MEMORANDUM

FROM: FRIENDS OF THE MON MAQ DAM

RE: DNR GRANTS FOR THE MONTICELLO MAQUOKETA DAM

DIAGRAM # 1

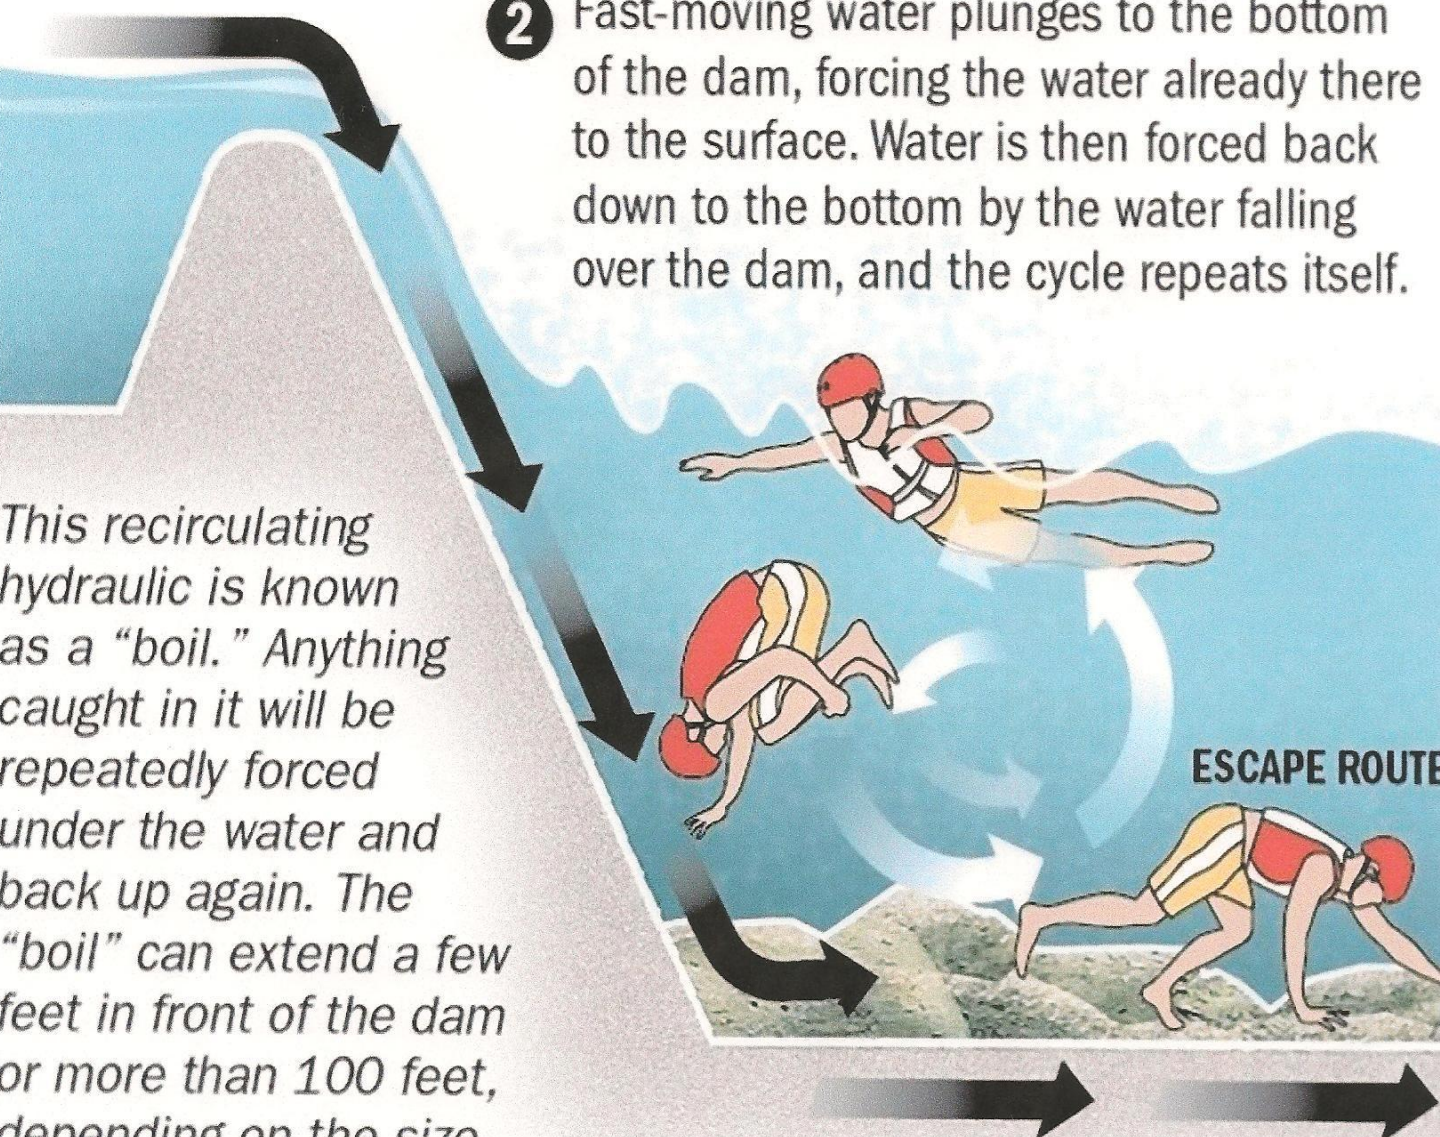
Diagram # 2 is similar. Both diagrams demonstrate an unimpeded plunge of water down the downstream side to the bottom of the river. The downstream water level is near the top of the dam. There is no apron above the water level on the downstream side.

The photograph below of the Monticello Maquoketa dam at normal water levels is markedly different from the situation portrayed in Diagrams #1 and #2. Water does not plunge over the side of the dam to the bottom of the river. It is intercepted by the apron. The apron is above the downstream water level. The apron is about 20 feet wide. The apron totally eliminates any "drowning machine" action caused by

Picture 3: Recirculation below the dam traps debris and other material. Known as a "drowning machine," the recirculation can be fatal to anyone trapped within it.

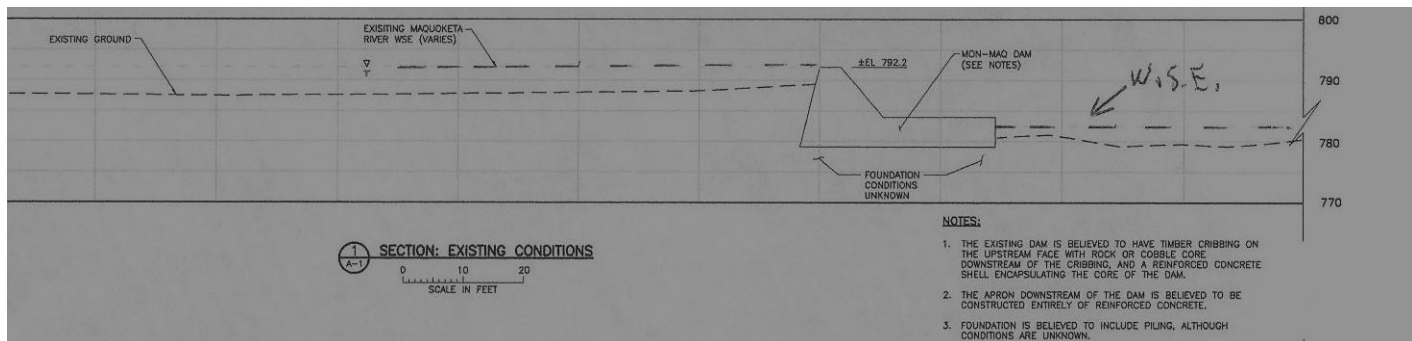
The text accompanying the photo makes no mention of the real hazard here. This is not a photograph of the Maquoketa River at normal water levels. This is a photograph of the river at a high flood stage. Ninety percent of the normally visible dam is submerged in this photo. The apron of the dam, normally visible, is 6 or 7 feet underwater. The river bed below the apron would be 10 or 11 feet underwater. The river is a "serious hazard for visitors to the water trail" at flood stage, regardless of whether there is a dam or not or whether the project selected by the Jones County Conservation Board, designated as "Option A", replaces the dam. To imply, based on this flood stage photo, that the dam presents "dangerous hydraulics" or a "drowning pool" at normal or low water levels, when the public is in close contact with the dam, is grossly misleading.

We believe the above photo was taken during the July 2010 flood resulting from the failure of the Delhi Dam. According to the United States Geological Survey (USGS), this flood has a 0.2% to 1 % chance of reoccurrence in a given year or, expressed another way, we can expect reoccurrence of this flood once every 100 to 500 years. USGS, Summary of U.S. Geological Survey Reports Documenting Flood Profiles of Streams in Iowa, 1963–2012 (Table 7).

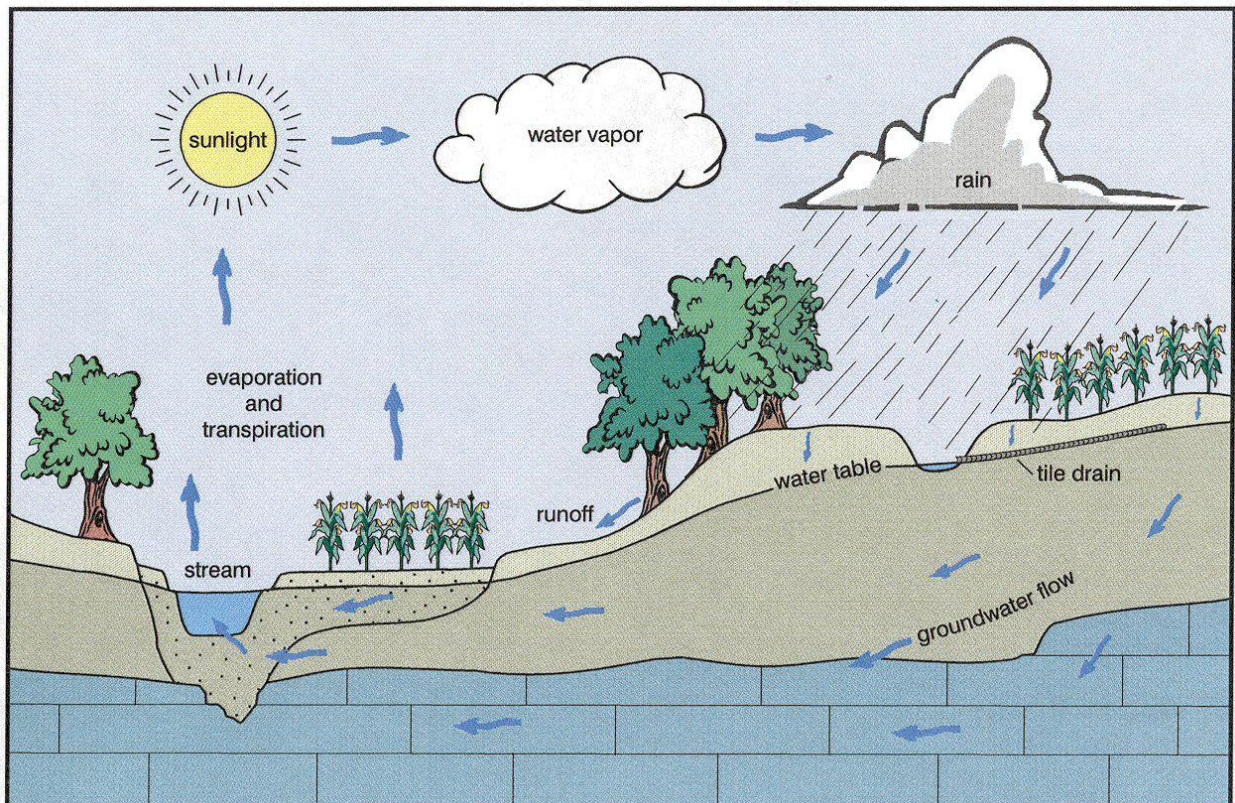
It should be noted that the boundaries of the Area of Potential Effect, as shown on Figure A-8 in the Barr Engineering report, are, with rare exception, very close to the shorelines of the Maquoketa River. They do not include, for example, most of Riverside Gardens, a park which has wetlands which may be affected by the lowering of the river. Riverside Gardens is not even labeled on Figure A-10, Locations of Potentially Impacted Features. Therefore, the Barr Engineering review of impact on wetlands may be incomplete.

Figure 1. Preliminary design to remove a large portion of the dam and add arching rows of boulders across the channel.

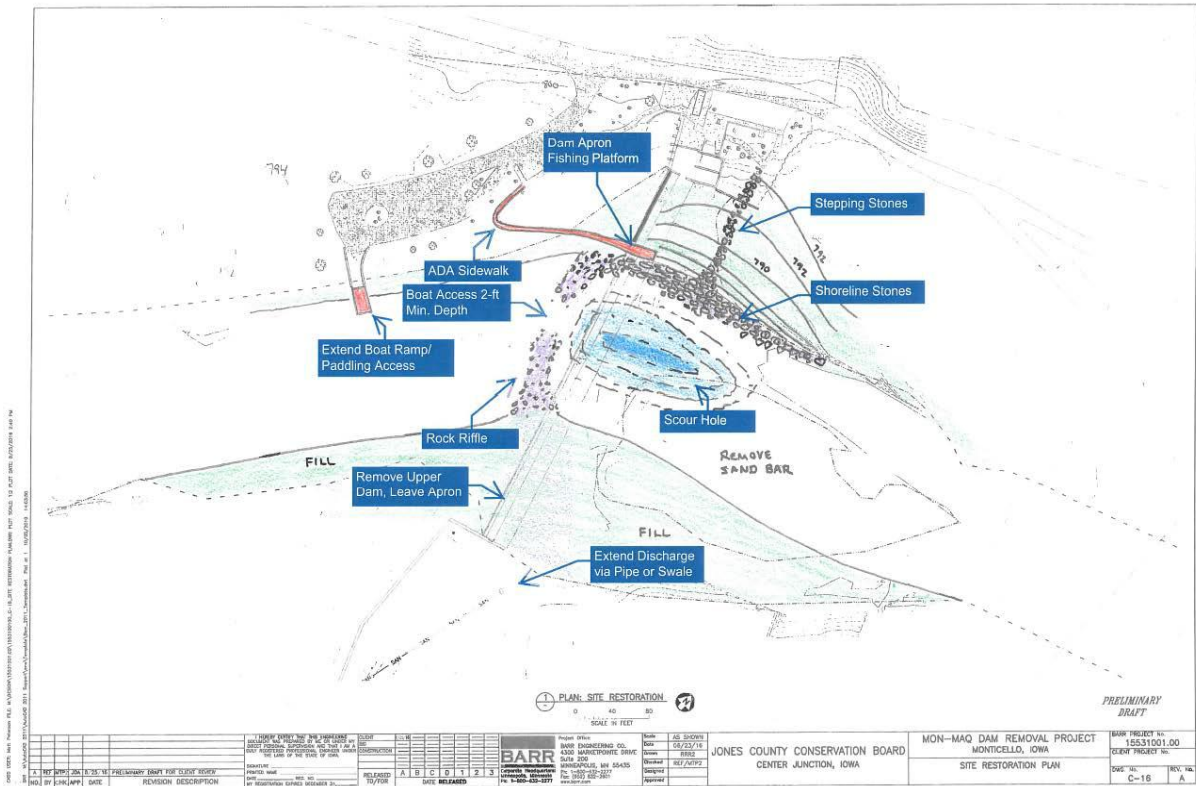
Please note that the goal is to provide "safe paddler/tuber passage . . . **at most flows** (emphasis added)." At what flows will paddler/tuber passage be unsafe? One must wonder at what flow any tuber would be safe going over this. As far as motorboats, mentioned in the JCCB's website document "Maquoketa River Mon/Maq Dam Project" at 1, this would be a high risk proposition at all water levels, especially for upstream travel. For all users, of course, flood stage flow will be unsafe. A paddler may hit submerged or visible boulders or debris which they cannot evade due to the rapid flood currents.

Option A also has a remnant of the apron being used as a fishing platform next to the edge of an 6 foot deep rock lined scour hole with fast current and passing watercraft. See Appendix B (map of Option A). With respect to drowning risk, this is obviously more dangerous than falling two feet off the current apron into 2.5 feet of water with a slow current and a riverbed lined with a sandy gravel base. Construction drawing at page 13 above; audio recording of August 24, 2017 JCCB Board meeting with reading of September 14, 1988 dam inspection report.
